PROJECT NUMBER: SP2022-016

PROJECT NAME: Site Plan for Incognito Winery

SUBJECT: SP2022-016; Site Plan for Incognito Winery

REQUEST for VARIANCE:

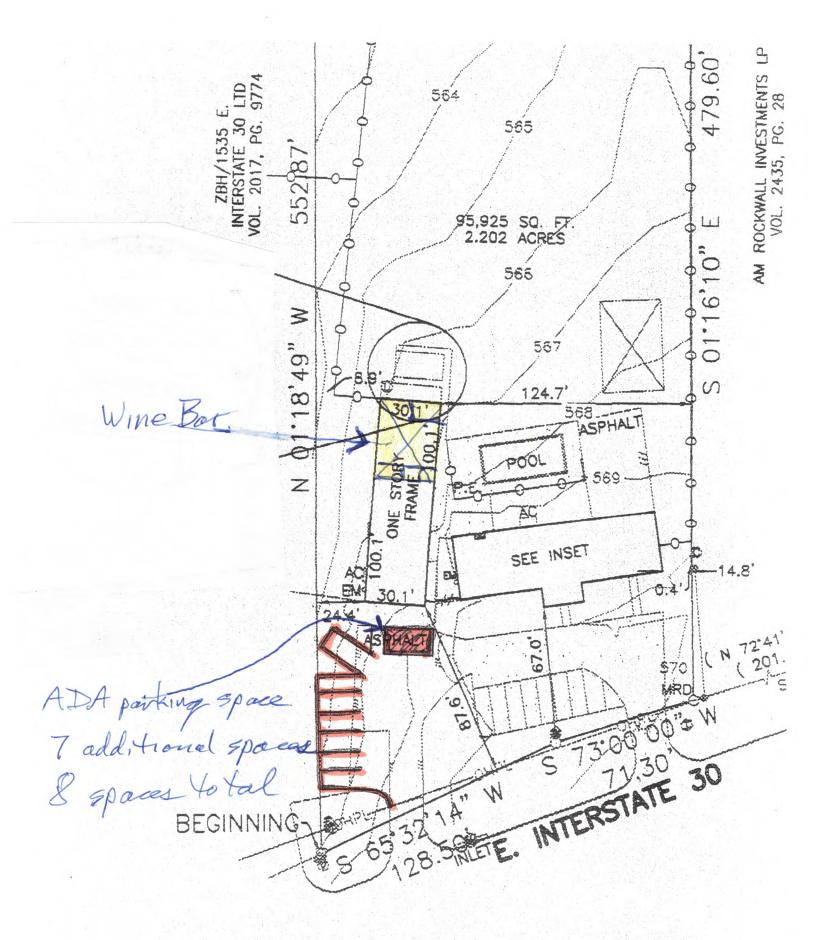
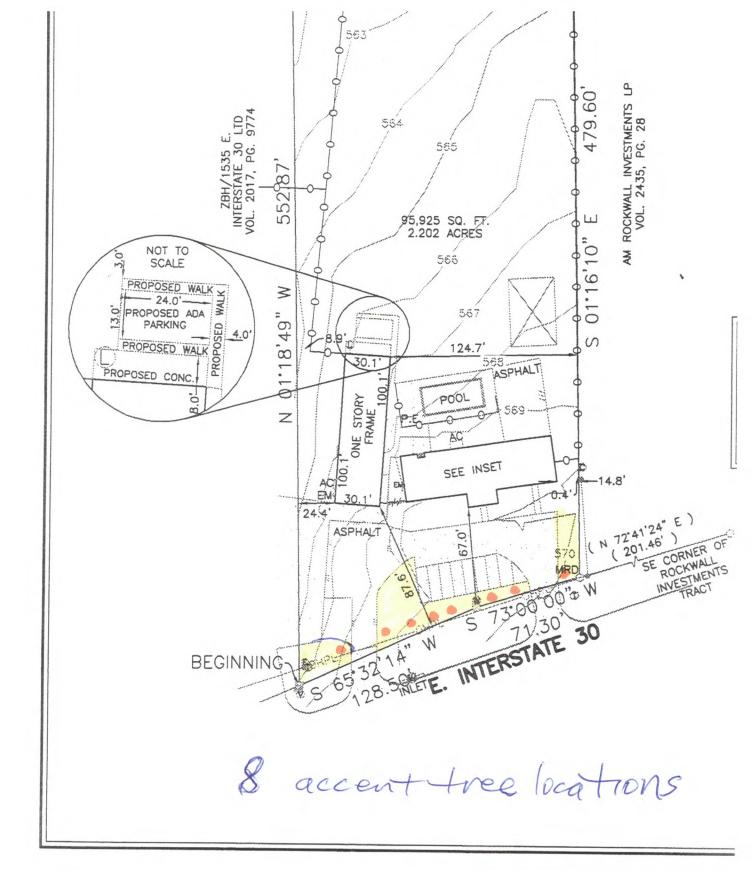
For the following, please see that attached survey. I have colored the grass at the front of the property in yellow for ease of visualization.

<u>Canopy Trees</u> – I have a thin space at the front of my property which is not concrete. See survey attached. There are power lines overhead so I request a variance to put in 8 accent trees in lieu of canopy trees that are known to be drought tolerant such as Desert Willow, Redbud, Prairie Flameleaf Sumac, Texas Persimmon, Texas Mountain Laurel, American Smoke Tree & Texas Redbud. The locations of the trees are identified on the attached survey with orange dots.

<u>Irrigating the Accent Trees</u> – I request a variance so as not to have to put in irrigation for the accent trees. The building is over 50 years old and has no sprinkler system anywhere on the property and to irrigate the accent trees I would have dig up the parking lot to put in irrigation and then tie it into the building.

<u>Parking</u> – In my original application I was told I would need 8 parking space, one of which needed to be an ADA parking space. Now I am told I need 12 spaces.

The church has 7 spaces and I request to be able to share the church spaces when Incognito is open.

The Church only has services on Sunday and Incognito will not be open on Sundays. Therefore, Incognito will be able to use the church parking spaces for the times Incognito is open, and conversely, the church will be able to use the parking spaces in from of 1541 when they are open on Sundays.
